SUBJECT: SEABROOK STATION, UNIT NO. 1 - RELIEF FROM ASME CODE
OPERATIONS AND MAINTENANCE CODE ISTB 4.3(e)(1) TEN-YEAR
INTERVAL INSERVICE TEST FOR CONTAINMENT SPRAY PUMPS CBS-P9A
AND CBS-P9B (TAC NO. MB6676)

SAFETY EVALUATION BY THE OFFICE OF NUCLEAR REACTOR REGULATION

REVISED PUMP RELIEF REQUEST PR-1

SEABROOK STATION, UNIT NO. 1

Figure 1

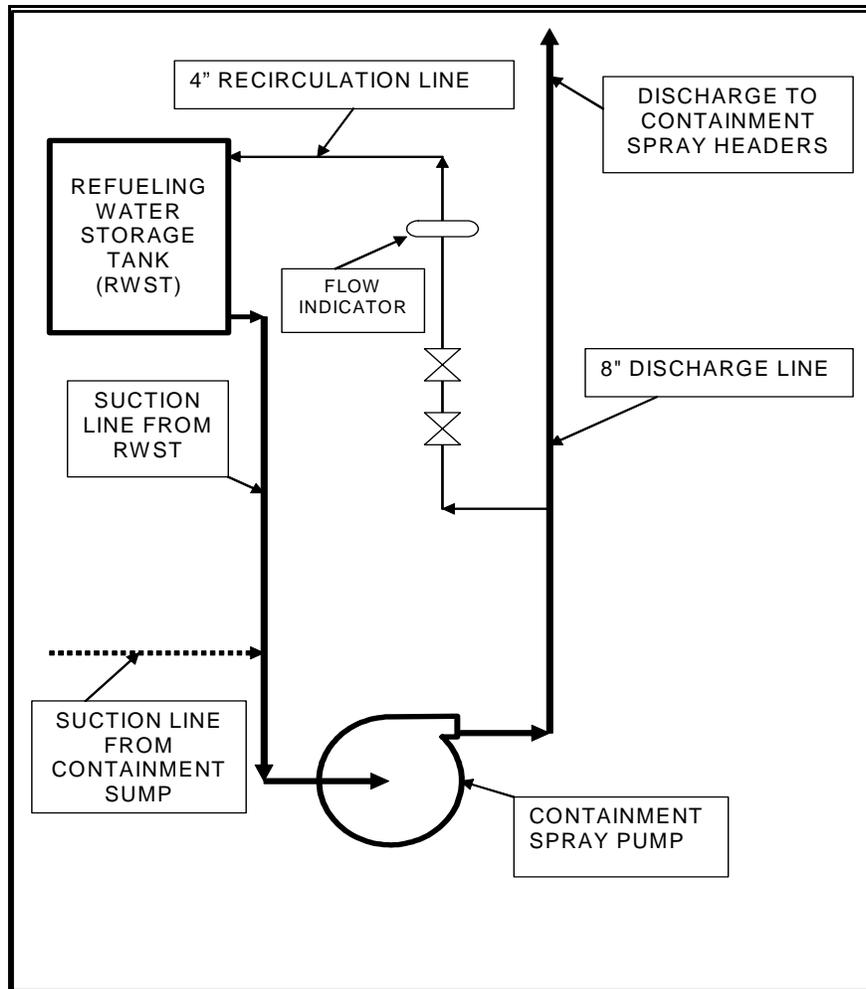
Containment Building Spray Pump Flow Diagram

Figure 2a

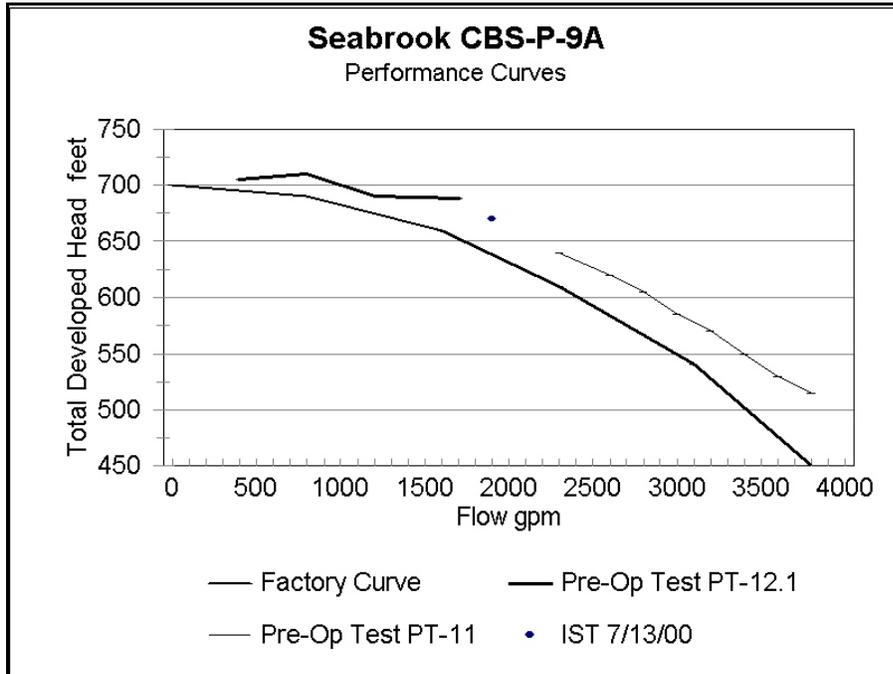
Figure 2a is reproduced from curves provided by the licensee in its submittal dated August 18, 2000, and compares performance data for pump CBS-P9A taken both at the factory and during pre-operational testing with a recent IST hydraulic data point. Figure 2b is plotted from data provided in the licensee's submittal dated September 8, 2000, and consists of performance data taken from all ISTs performed on CBS-P9A. Different reference flow rates are plotted on the same graph according to the date the test was performed. At higher flow rates, a lower pump head is expected. Figures 3a and 3b provide similar data for containment spray pump CBS-P9B.

Based on the factory curves, the shutoff head of both containment spray pumps is 700 gpm. The staff also noted that the pre-operational performance curves are offset from the factory curve, possibly due to higher system resistance and methods of collecting and reducing the performance data. The representative IST points plotted on these two curves either coincide or are above the pre-operational performance curves. The staff also observed that the slopes of the pump/head curve measured at the factory and the pre-operational test curves show very small changes in the pump total developed head up to 2000 gpm. For example, for CBS-P9B, the total developed head at approximately 1900 gpm is 680 feet. At this value, the total

Figure 3a

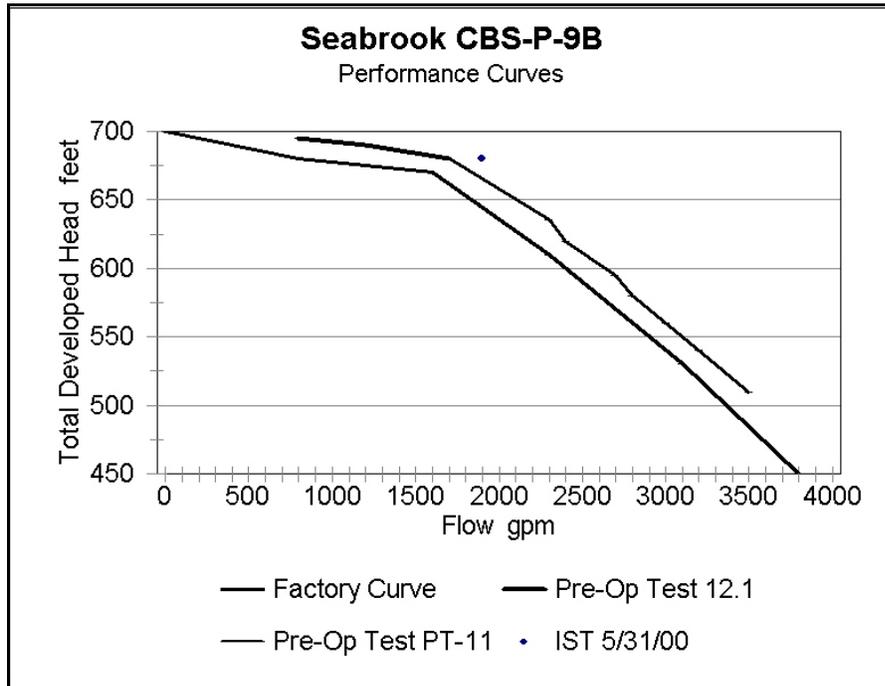
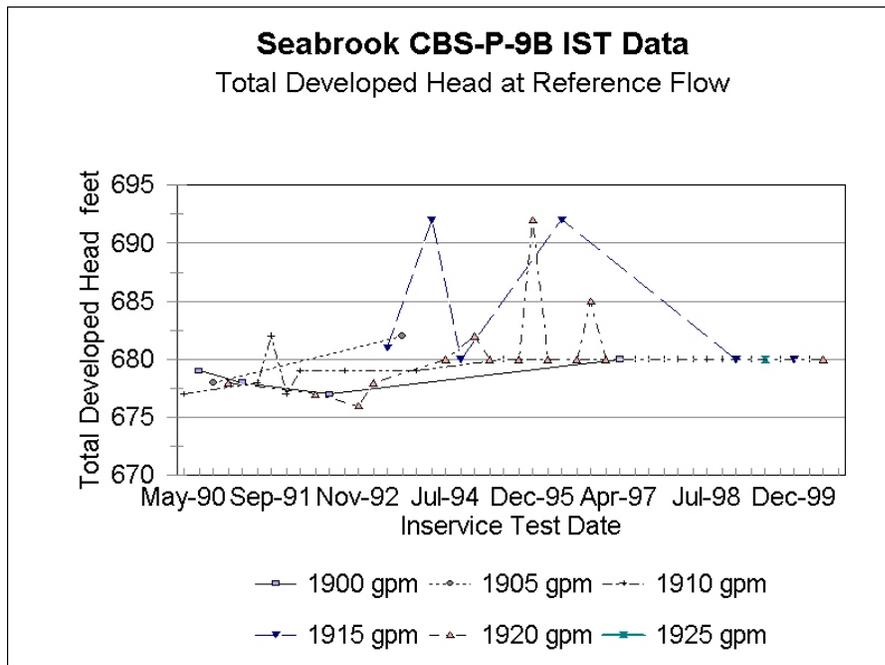
developed head is within 3% of the shutoff head of the pump. At 2400 gpm, the curve plotted using data from pre-operational test PT-11 shows that the total developed head is approximately 620 feet, or 12% below the shutoff head of the pump. At 3000 gpm, the total developed head drops to approximately 560 feet, or 20% below the shutoff head.
